DATE: June 30, 2015

ST-020-15

SUBJECT: 33” Modulating Gas Furnace – Stuck Gas Valve Issue

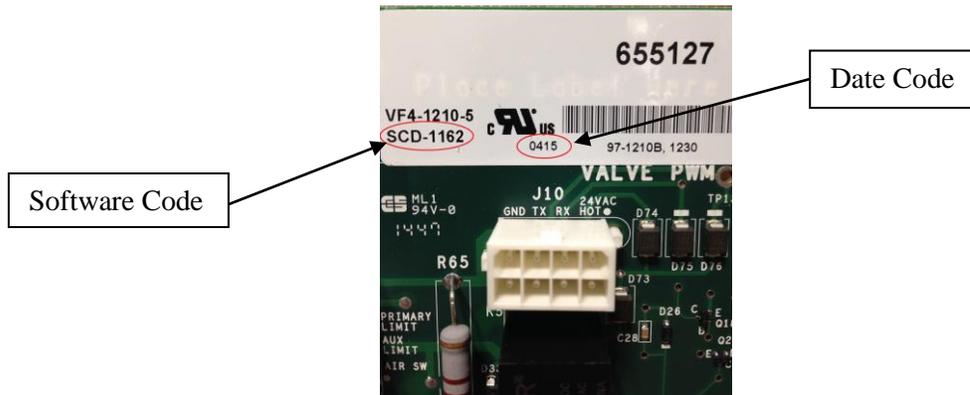
One item we noted is the control board for the furnaces drove the gas valve to the home position after each cycle. It has been decided to change the logic on the control board to stop this command. Control boards with the logic change can be identified with the software code “SCD 1162” on the label. See photo below for location of software code. The four digit date code is located to the right of the software code. In the photo below, the date code of “0415” indicates this board was produced the fourth week of 2015.

Production of furnaces with the new logic control board began the first week of March; furnaces produced with date code of W1C5 and later contain the new board. Source 1 inventory has also been stocked with the new control boards; boards shipped as of the date of this letter contain the new logic.
